RESOLUTION 2017-065

A RESOLUTION OF THE CITY COUNCIL OF NIXA, MISSOURI, APPROVING THE MEADOWBROOK PRELIMINARY PLAT

PLANNING AND ZONING COMMISSION COMMUNICATION

REQUESTED ACTION: Preliminary Plat, Meadowbrook

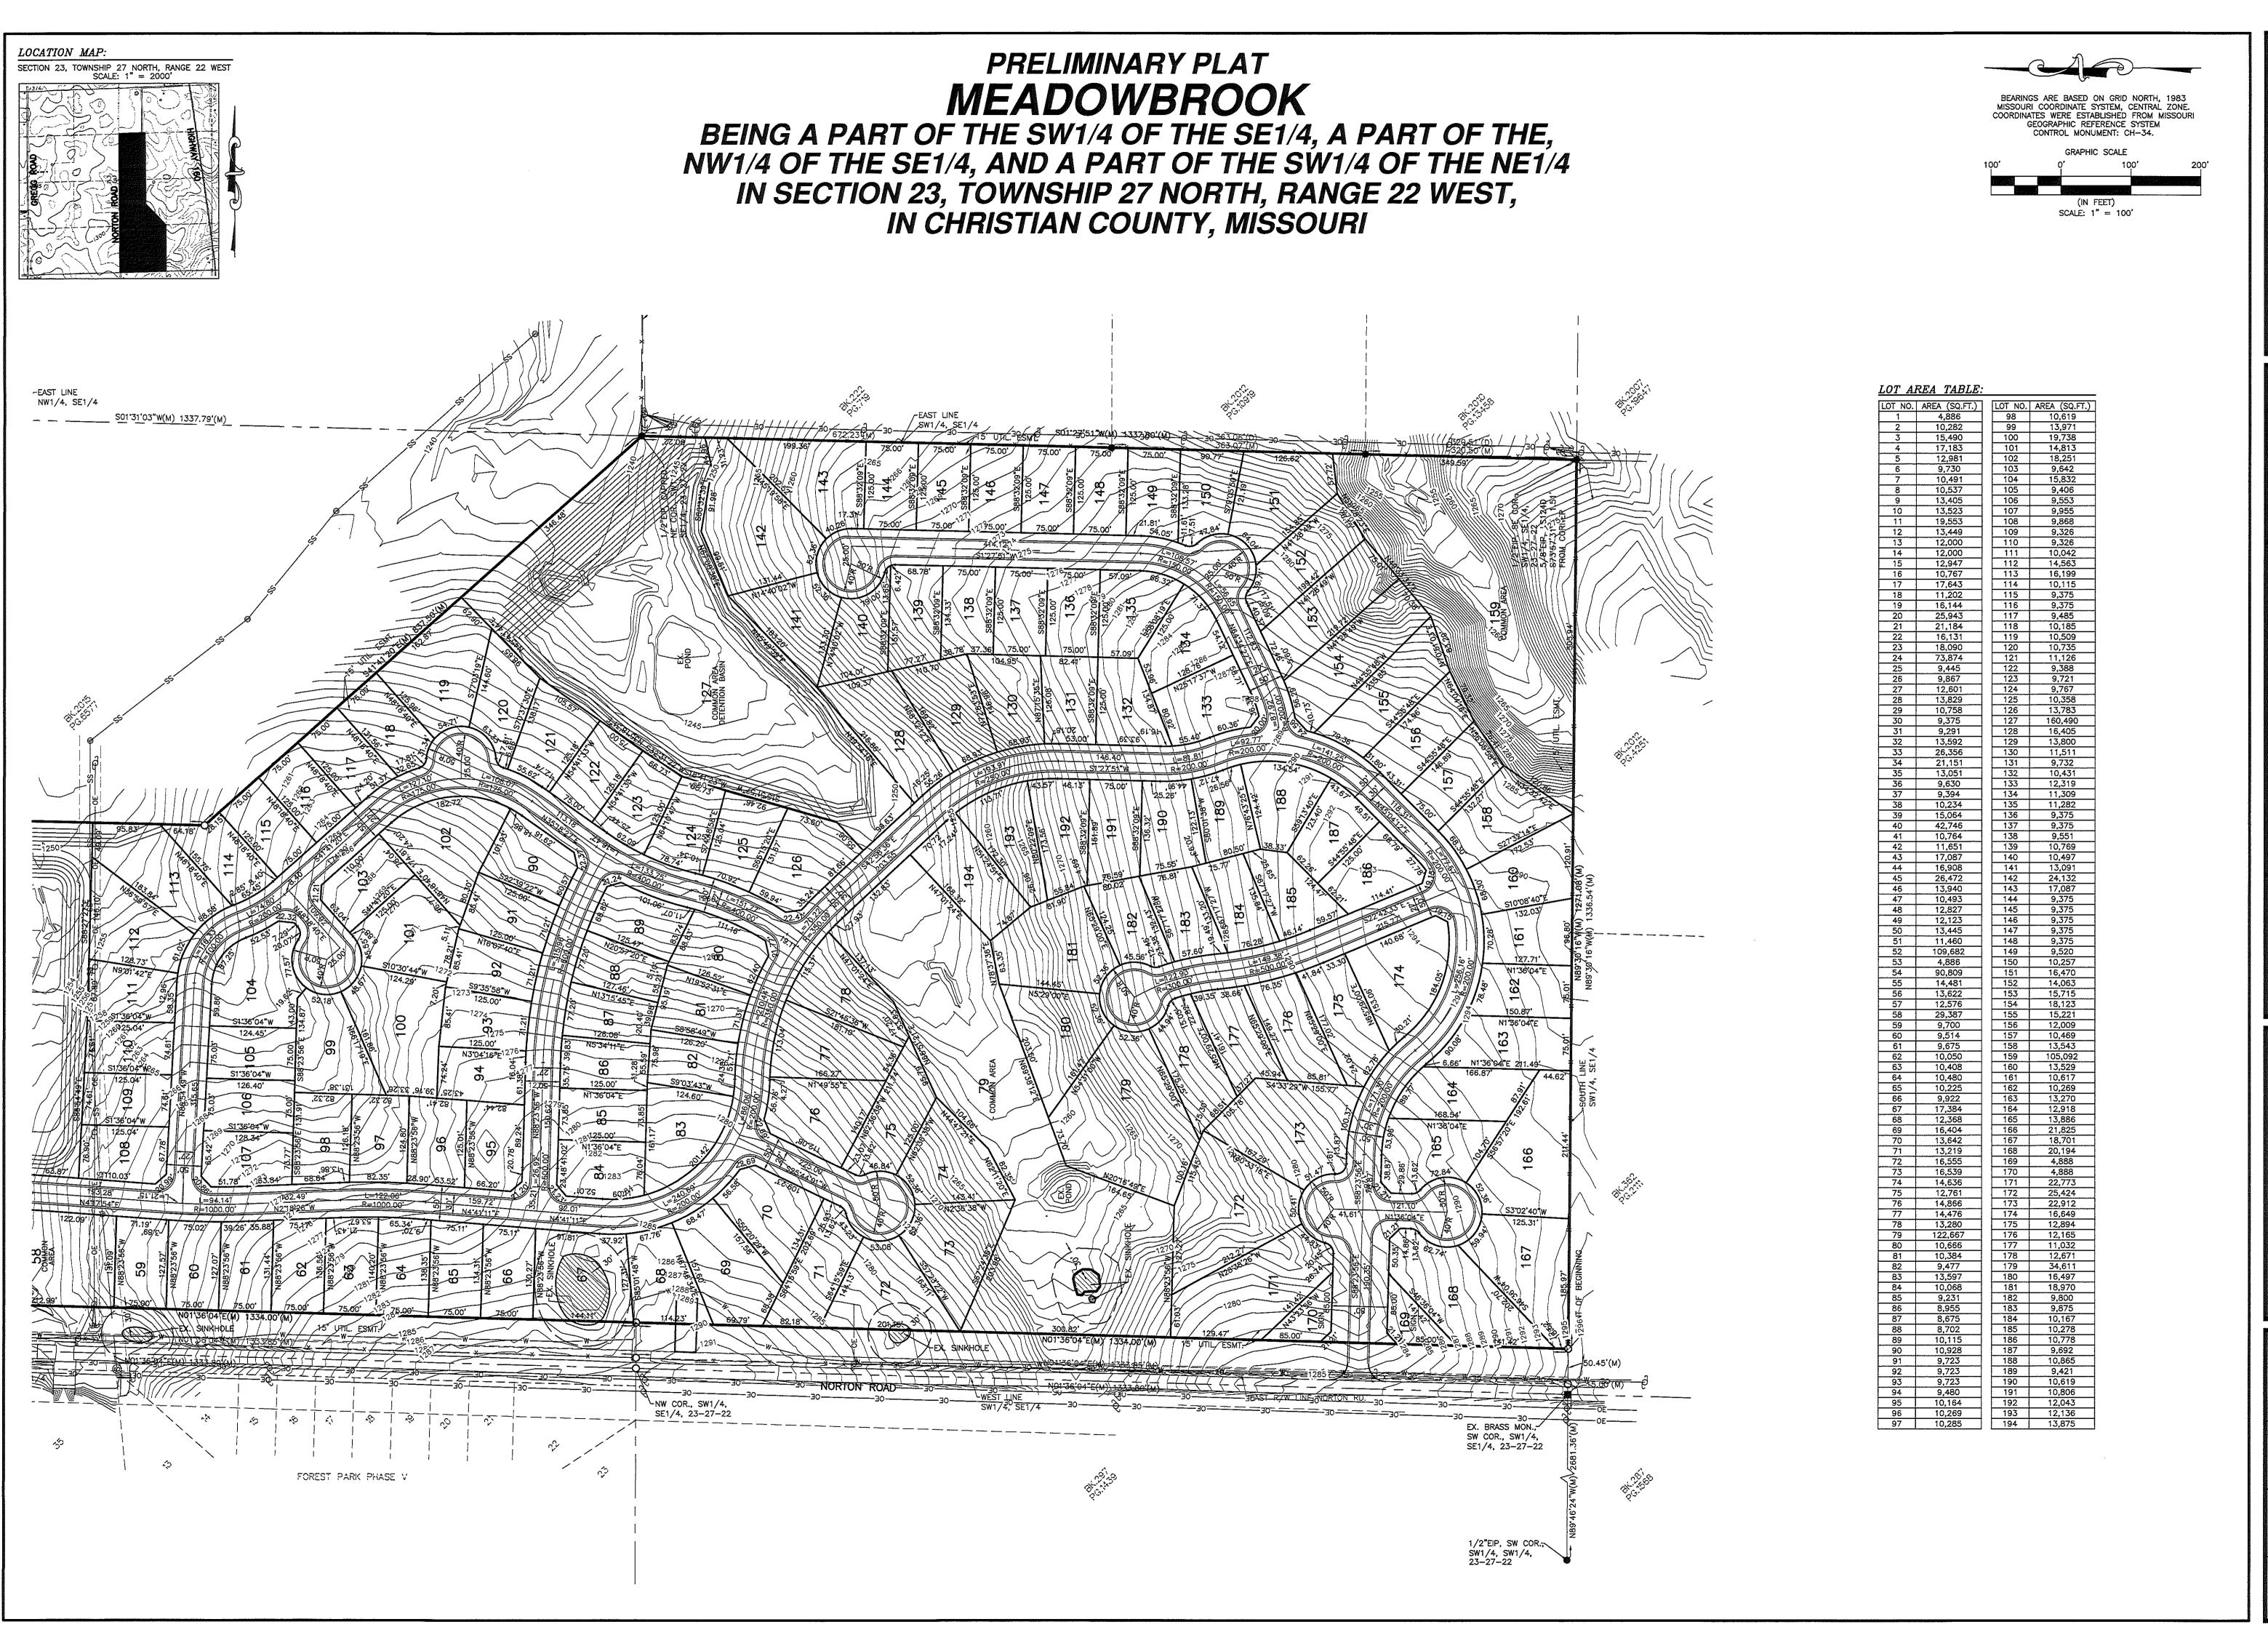
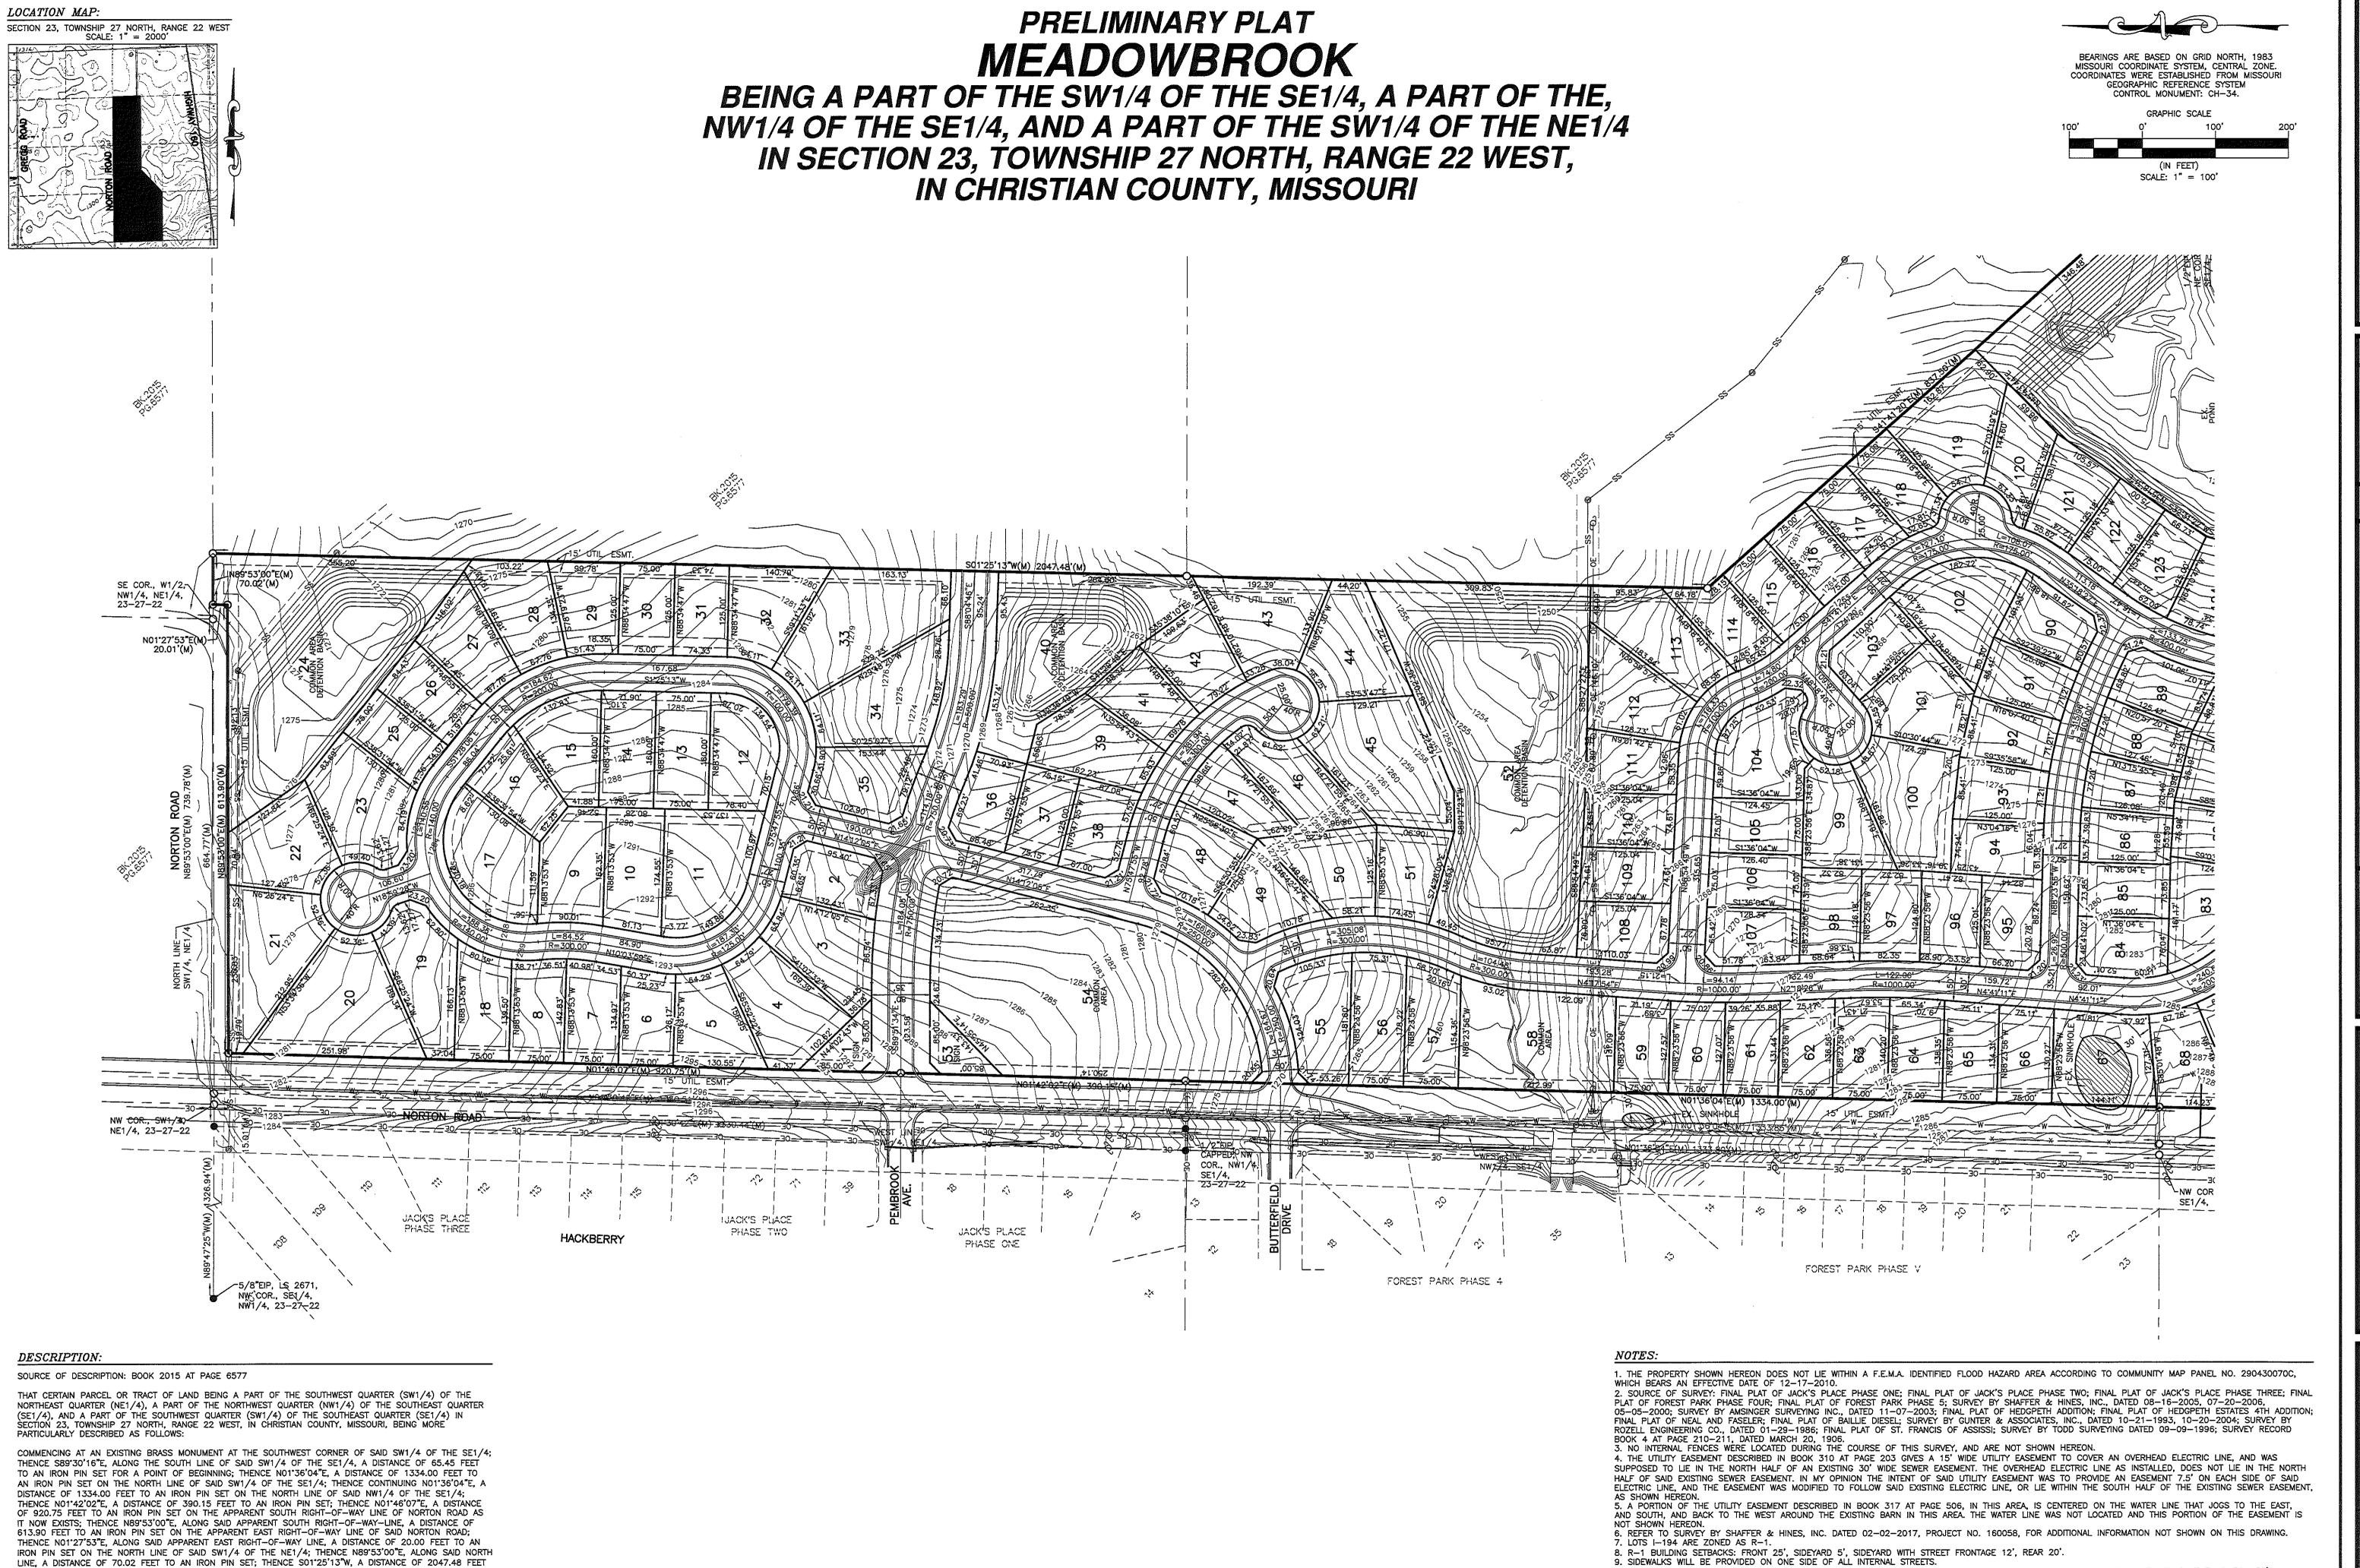
- 7. Lot 159 is reflected as a Common Area. No access is reflected on the preliminary plat. The final plat must reflect a perpetual mutual access easement to ensure that the area can be maintained.

- 9. The preliminary plat includes a combination of 30' wide and 27' wide streets. Streets constructed as 27' wide streets and shall only allow parking on one side of the street. To ensure that pedestrian site visibility is maintained, the no parking side of the street shall be coordinated with the side of the street that sidewalks are required.

- 7. Lot 159 is reflected as a Common Area. No access is reflected on the preliminary plat. The final plat must reflect a perpetual mutual access easement to ensure that the area can be maintained.

- 9. The preliminary plat includes a combination of 30' wide and 27' wide streets. Streets constructed as 27' wide streets and shall only allow parking on one side of the street. To ensure that pedestrian site visibility is maintained, the no parking side of the street shall be coordinated with the side of the street that sidewalks are required.
